**BELL BEND NUCLEAR POWER PLANT
DATA TO SUPPORT THE
WALKER RUN CLOMR REQUEST
BNP-2012-070 Docket No. 52-039**

Reference: 1) Case No.: 12-03-0820R
Walker Run
Community: Township of Salem, PA
Community No.: 420625

Bell Bend Nuclear Power Plant Flood Study Report Walker Run

Walker Run Flood Study Report

10/28/2011 11:11:59 AM
P:\FILES

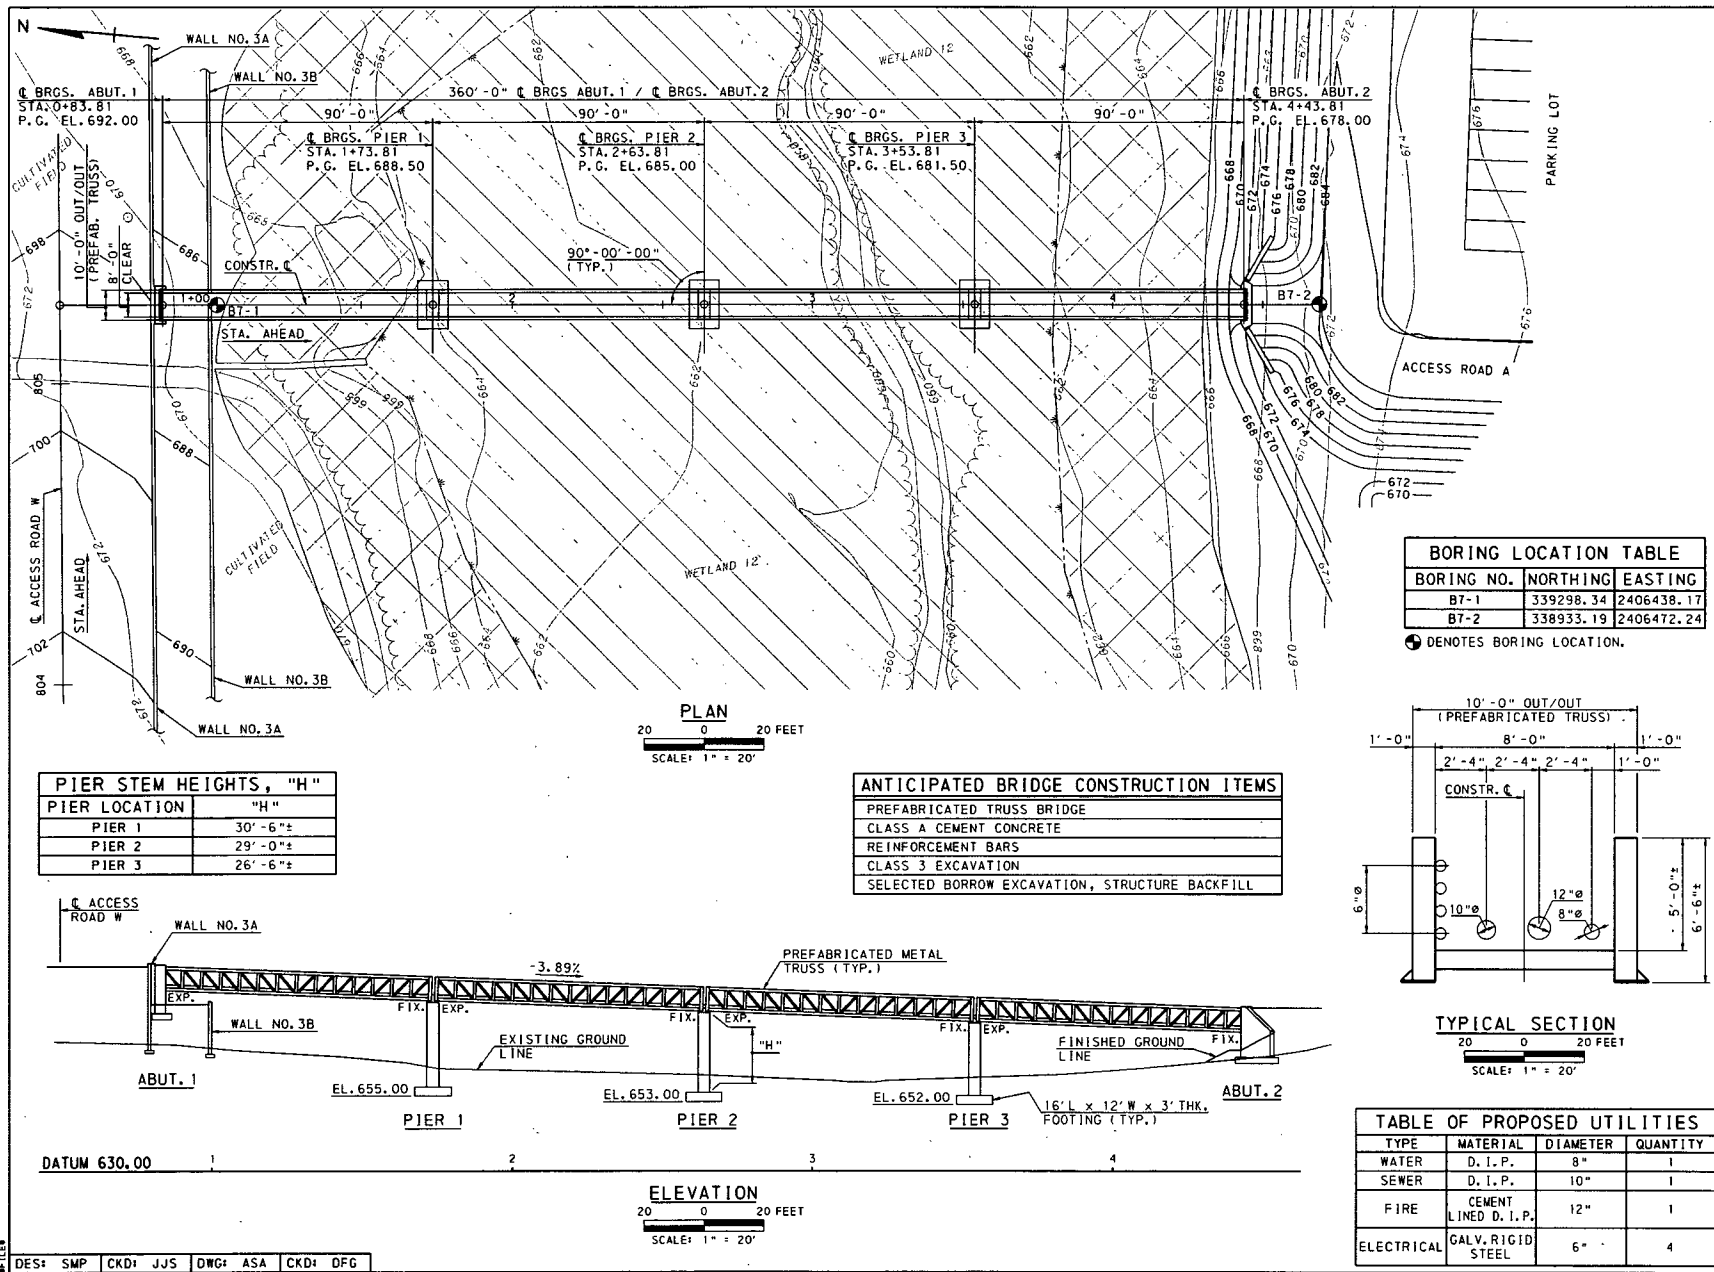
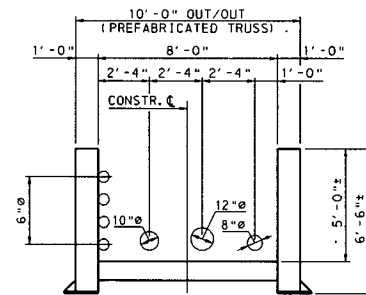
2. Our review of the submitted design plans for the proposed bridges over Walker Run and Unnamed Tributary to Walker Run revealed that they are not printed to the appropriate scale. Please submit all drawings to scale.

The bridge drawings were inadvertently copied at the wrong scale. Full size plan sheets have been included with this submittal.
